**RE: ADA Technical Review of Faces of Hope Building**

In response to your request, please find a formal technical review of the parking lot, the pathway from the parking lot, the access ramps to the customer entrance, and areas in the facility that are accessible to the public for the Faces of Hope office located at 209 West Main Street in Boise.

## **ADA Evaluation Addendum**

Figure 1 - Aerial view of parking lot

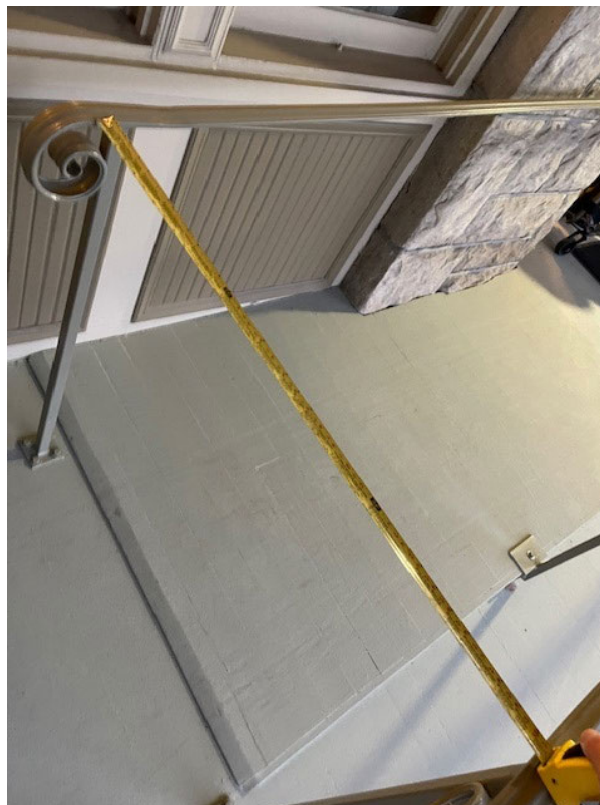
**Noncompliant Findings:** The parking lot located at the rear of the building has no van accessible parking space.

**Recommendation:** Designate a van accessible parking space in the rear of the building closest to the wheelchair ramp that provides access to the front entrance of the building. This parking space must comply with Section 502, including the width of the parking space and access isle, van accessible signage, and an accessible route directly connecting from the access isle to the wheelchair ramp at the front of the building.

The photos below show an arial view (Figure 1) of the recommendation van accessible parking space and the accessible route to the ramp, and a surface view (Figure 2) of the recommended parking space. The cross-slope of the recommended parking space is 1.45 degrees, which is less than required maximum 1.48 degrees or 2.08 percent.

- a. We have identified and marked a handicap parking spot in the rear parking lot with an area large enough for loading/unloading.

Figure 4 - Photo of ramp landing being measured

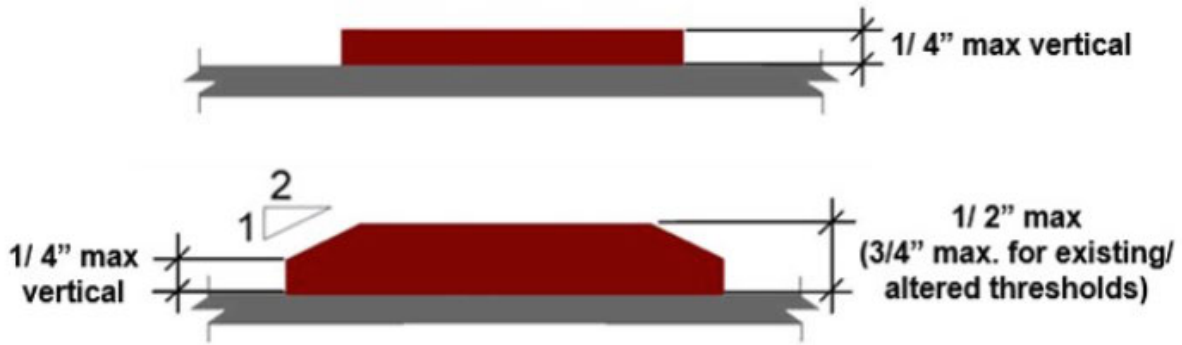
**Noncompliant Findings:** The ramp, which includes changes in direction, does not have landings that are 60 inches by 60 inches in clearance. The photo below (Figure 4) shows a measurement of 47.5 inches, which is less than the required 60 inches.

- a. The existing ramp at Boise location does not meet current ADA slope and handrail requirements. However, because the property is designated as a historical structure, it is grandfathered under ADA Title III regulations, which allow certain modifications or exemptions to preserve the historical integrity of the building. As such, alterations to the ramp are not required unless they can be made without compromising the historic character of the site.
  - i. If a client is in a wheelchair, employees will direct the client to Meridian location that is wheelchair accessible.
